ADDENDUM NO. 5
TO
CITY OF FRESNO
PUBLIC WORKS STANDARD SPECIFICATIONS
ADOPTED MARCH 4, 1970
RESOLUTION NO. 70-36
UPDATED VERSION APPROVED October 15, 2014

This addendum is attached to and made a part of the above-entitled standard specifications.

The following City Standard Drawings have been amended as indicated below:

CITY OF FRESNO
ITS-18A

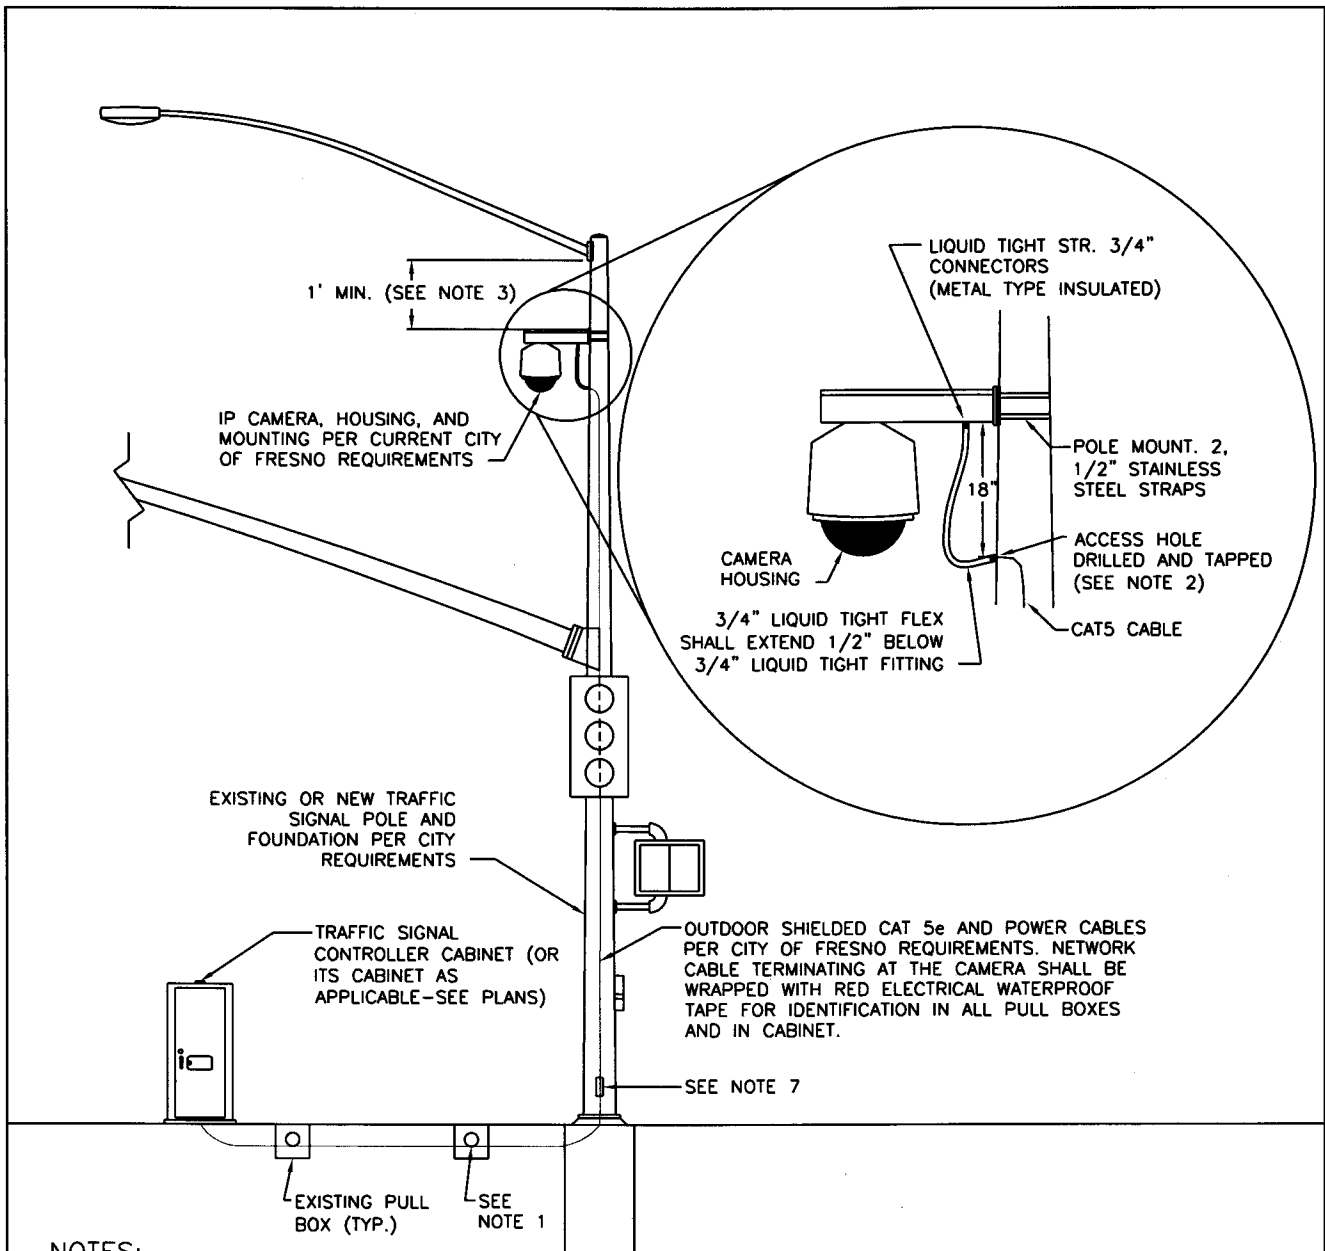
- E-36 Changed 2-pole branch circuit breakers to 1-pole.
- ITS-18A Added (Gooseneck) to Title Block
Added, Camera Cat 5 – "Red Taped"
Updated, access hole see note 1, replaced with text, "access hole see note 2"
Deleted reference, "See note 1"
Callout beginning with, Cat 5e, deleted, "and power cables". And inserted text after RED, "electrical waterproof."
Deleted, "See Note 2", replaced with text, "See Note 1"

Deleted "Note 1", text.
(Numbered Notes re-numbered accordingly.)

Note 1, inserted text after RED, "electrical waterproof", the word RED shall be made bold.

Note 2, Replaced second sentence with, "Use rubber grommet to seal."

Note 3, Removed period and Added, "or as directed by City engineer."

Note 4, Added.

Note 5, Added.

Note 6, Added.
